Subject: UniStar Nuclear Energy, NRC Docket No. 52-016
Response to Request for Additional Information for the
Calvert Cliffs Nuclear Power Plant, Unit 3,
RAI 370, Other Seismic Category I Structures

**Response to NRC Request for Additional Information
RAI 370, Questions 03.08.04-35, Other Seismic Category I Structures,
Calvert Cliffs Nuclear Power Plant, Unit 3**

RAI No. 370

Question 03.08.04-35

Figure 3.8-7 – {Conceptual Configuration of Dampproofing Membrane}

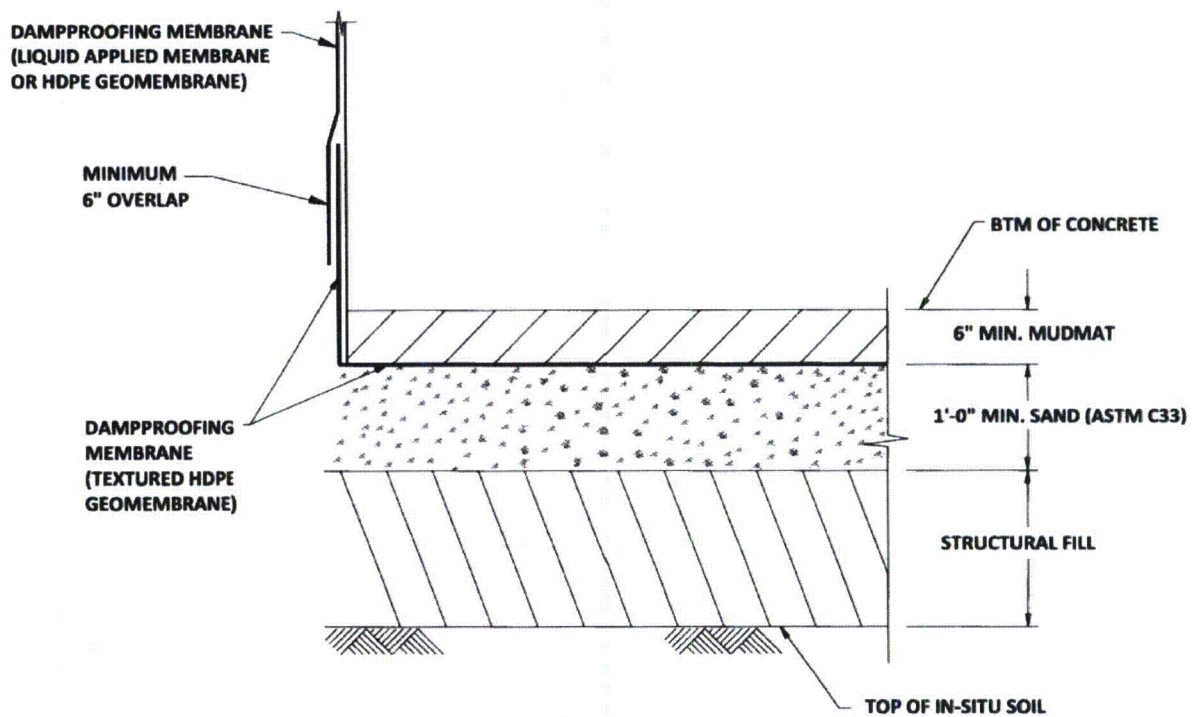
(1) Since waterproofing and dampproofing systems will be used for the EPGBs, ESWBs and Seismic Category I Intake structures, in FSAR Section 3.8.5.5 and Table 3.8-1, "Static Frictional Parameters," the potential sliding interfaces under the EPGBs, ESWBs and/or CBIS need to be revised to include the interface between sand/soil/backfill and waterproofing/dampproofing systems.

(3) FSAR Section 3.8.4.6.1 only provides the description of the waterproofing system for the NI common basemat structure. A description needs to be provided in the FSAR of the waterproofing and dampproofing systems to be provided for portions of other Seismic Category I structures below grade, including foundation walls and basemat, as well as buried utilities.

Seismic Category I EPGBs are located above the post-development groundwater level and are not in constant contact with the low-pH groundwater. As illustrated in Figure 3.8-7, the dampproofing system for the EPGBs consists of an HDPE geomembrane located between the mudmat and underlying structural fill. Dampproofing for below-grade walls consists of liquid applied membrane or HDPE geomembrane placed directly against concrete.

~~waterproofing is used for the EPGBs and ESWBs because they are located above the post-development groundwater table. As described in Section 3.8.4.6.1, a dampproofing system is used for the EPGBs (and will also be used for the TI), as illustrated in Figure 3.8-7. Therefore, the~~The potential sliding interfaces under the EPGBs and TI ESWBs are:

- ◆ Basemat-mud mat
- ◆ Mud mat- ~~dampproofing membrane structural fill~~
- ◆ ~~Dampproofing membrane - sand~~
- ◆ ~~Sand - structural fill~~
- ◆ Structural fill - soil stratum IIb

Note: the Mudmat - Dampproofing interface must be made by pouring the mudmat directly onto the textured surface of the HDPE used for dampproofing. Therefore, the Mudmat - Dampproofing interface resistance will be the full shear strength of the HDPE material, and the weaker interface will be the Dampproofing - Sand interface.
